Brightlingsea
Harbour
Commissioners

Morgan Marine Planning Application
User Group Hazard and Risk Assessment -
Safety of Navigation

Leisure Users - Bathymetric Information

Vessels leaving Proposed East Basin

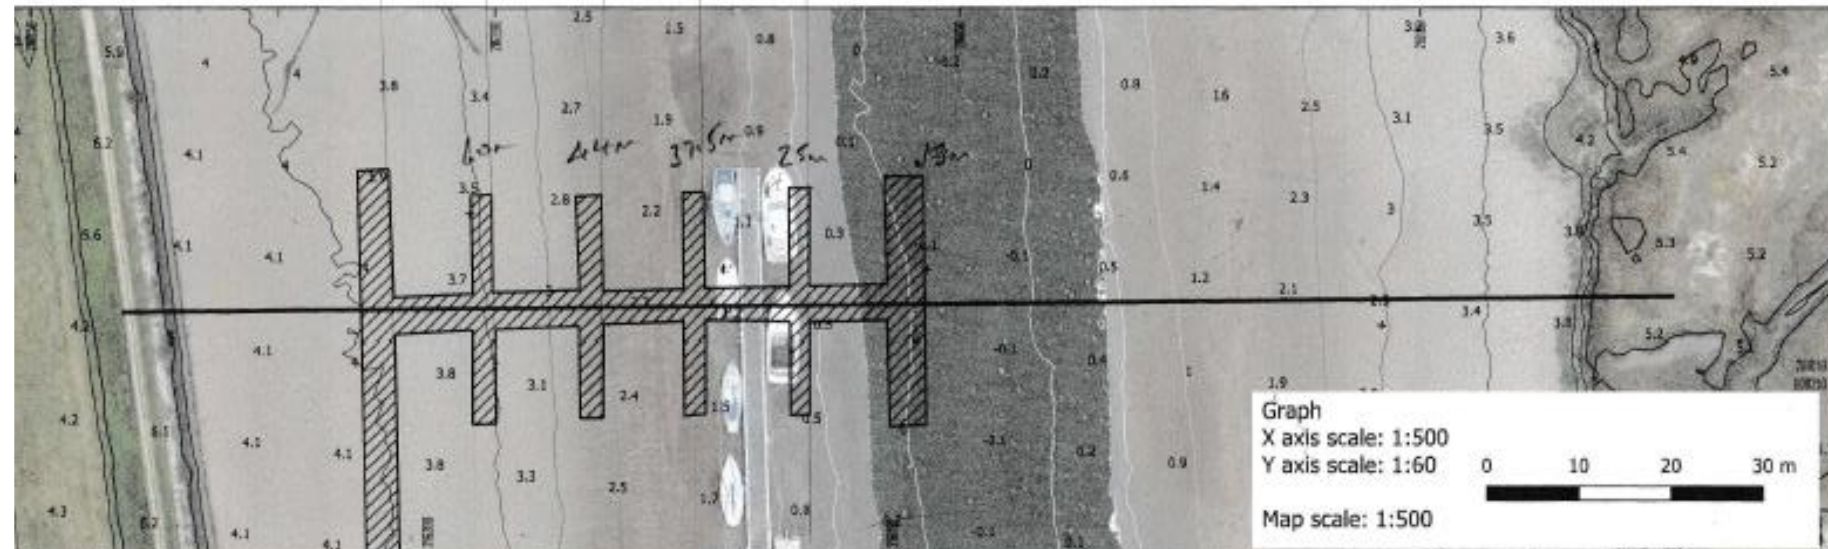
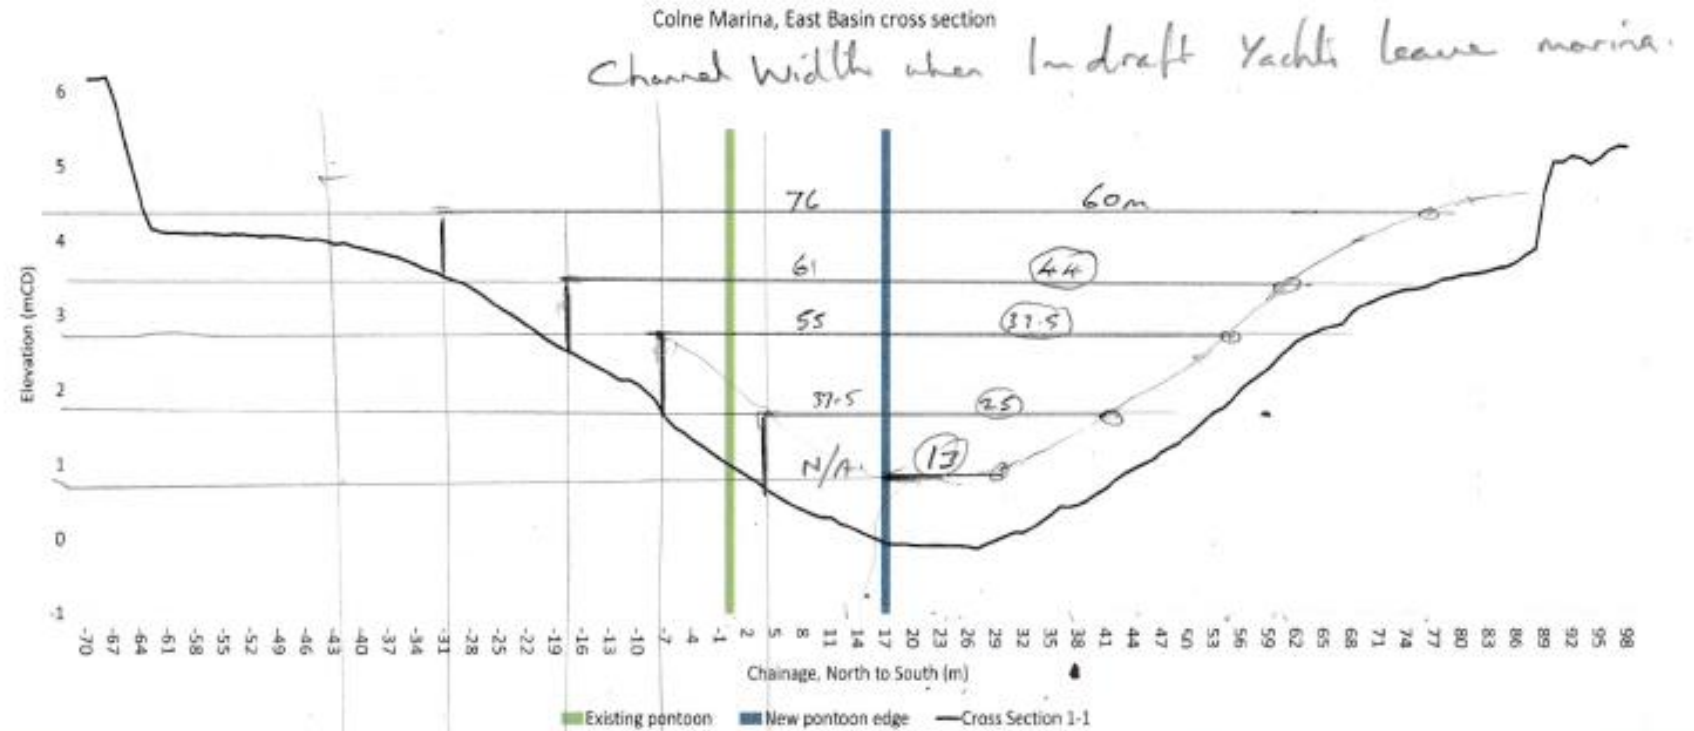
- Proposed East Basin Finger Pontoons shown.
- Based on 1m vessel draft.
- Water levels to exit marine finger pontoons shown.
- Only the southern most (deep water) pontoon has less than 25m channel width to turn out of marina.
- Southern Pontoon only 13m channel width.

4 Gigs Abreast - Oar tips of 7.62m with 4 gaps of 3m = 42.5m

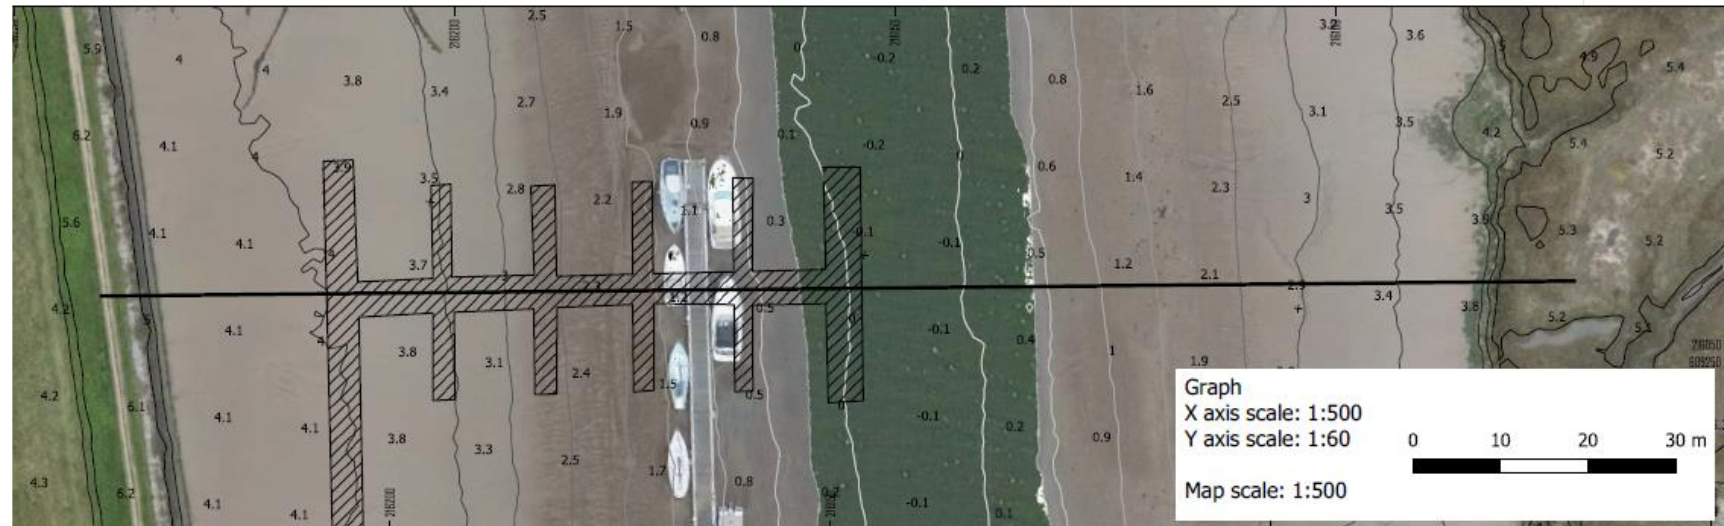
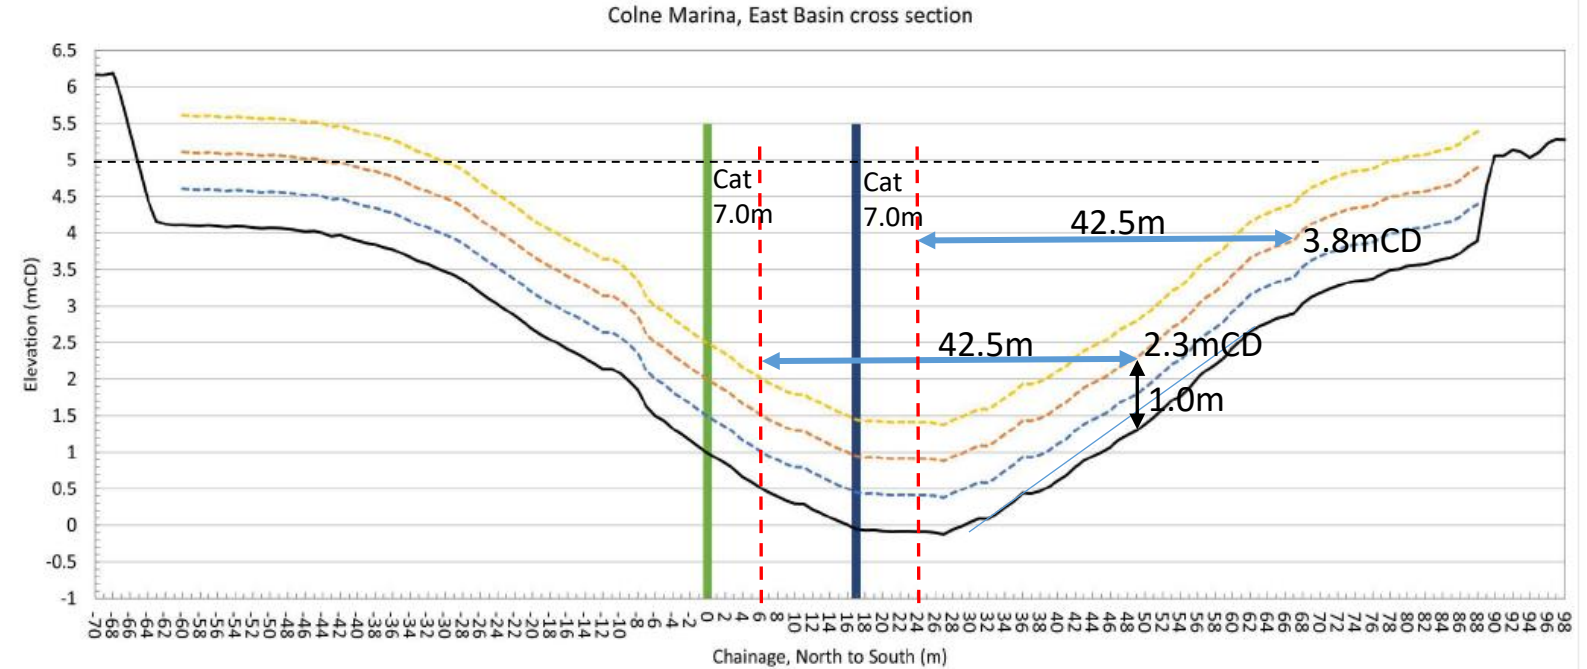
- Consider existing tide levels required for Gig races.
- 4 Gigs abreast
 - 4 gigs - unlikely but allows for yacht passing.
 - Oar tips – 7.62m.
 - Water depth at oars = 1m.
 - Min clear space – 3.0m.
 - Min total width – 42.5m.
 - Allow 7m wide vessel on pontoon.
- Existing pontoon - 2.3mCD
- Proposed pontoon – 3.8mCD
- Time required to run Gig races
 - 11 pairs at 2min intervals = 22min.
 - Races last 25min.
 - Fleet time = 47min.
 - Change = 30min.
 - No of fleets = 3
 - Total race time = $(3 \times 47) + (2 \times 30) = 201\text{min.}$

4 Gigs Abreast – Width = 42.5m - Tide MHWS = 5.0mCD.

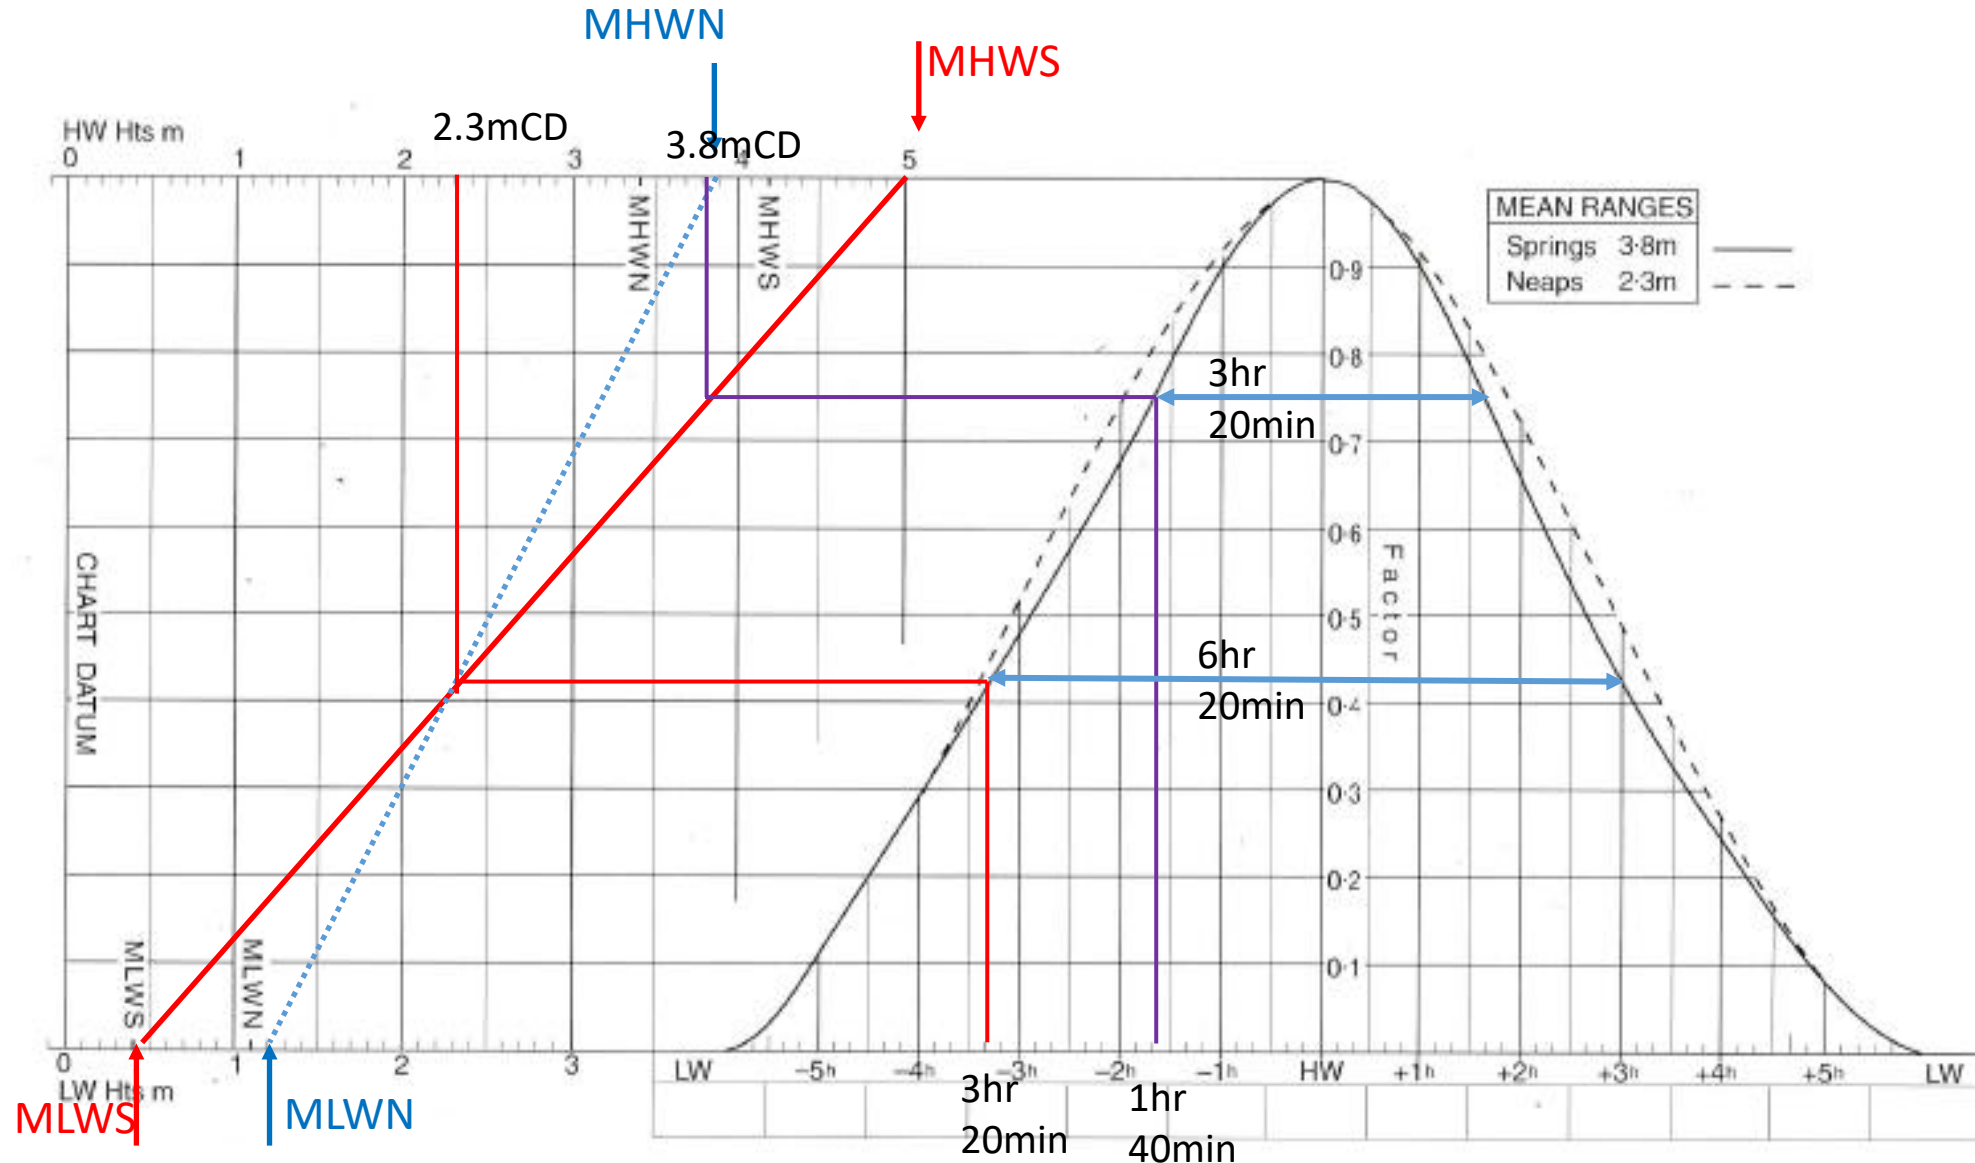
- Total time required for Gig races is 3hr 21min.
- Existing pontoon - race window is 6hr 20min.
- Proposed pontoon - race window is 3hr 20min.

CYC Sonata Yachts

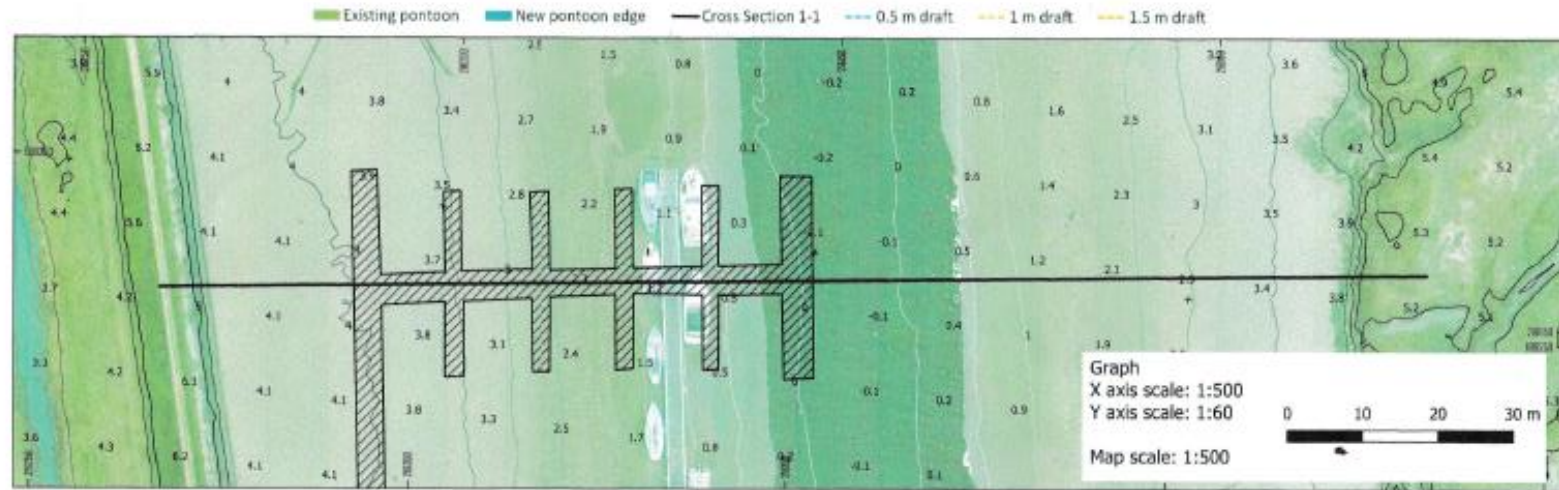
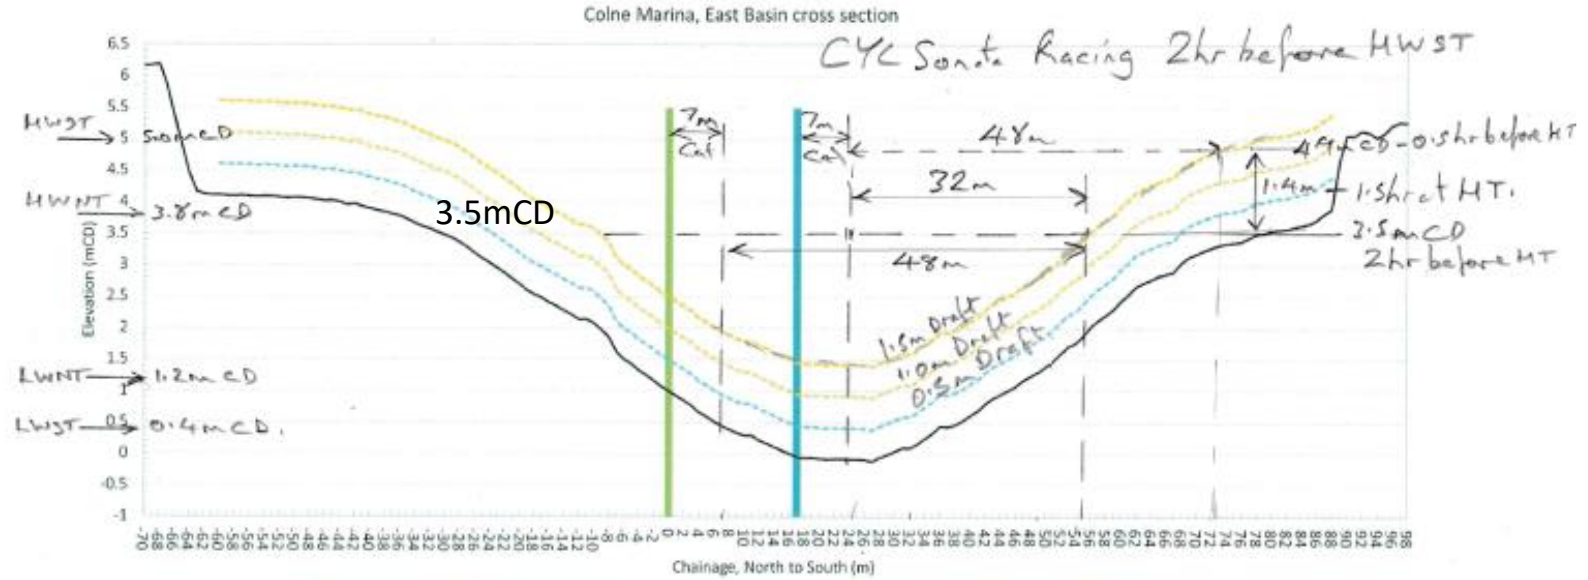
- Sonata draft = 1.5m.
- Sonata races can start 2hrs before MHWS at 3.5mCD, when the channel width is 48m.
- Existing pontoon - race window is 4hrs.
- Proposed pontoon - race window is 1hr.

Craft with 0.5m draft. – Moored at Hickman's boat yard

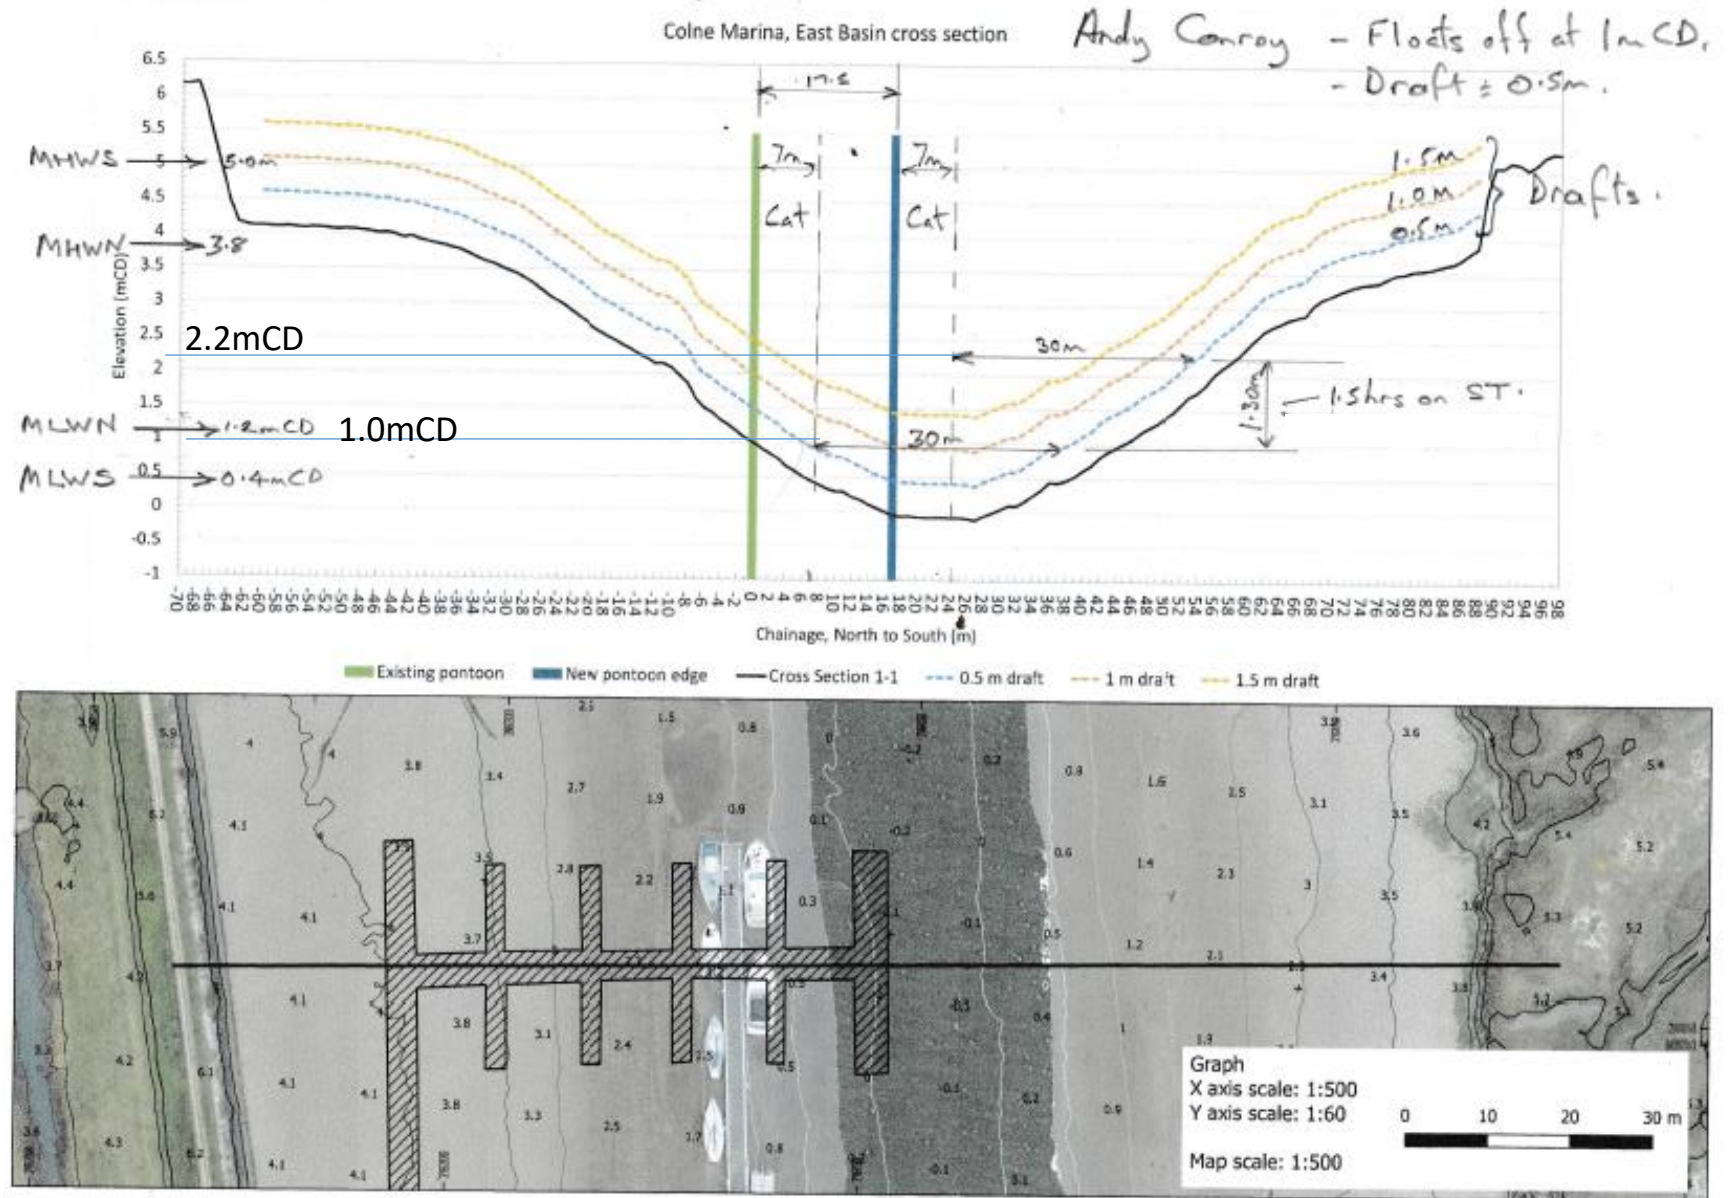
- Craft will float off from Hickman's tidal moorings at 1mCD.
- Existing pontoon - channel width at 1mCD tide level is 30m.
- Proposed pontoon – channel width at 2.2mCD tide level is 30m.
- Existing pontoon – Access window is up to 9hrs.
- Proposed pontoon - Access window is reduced to up to 6hrs.
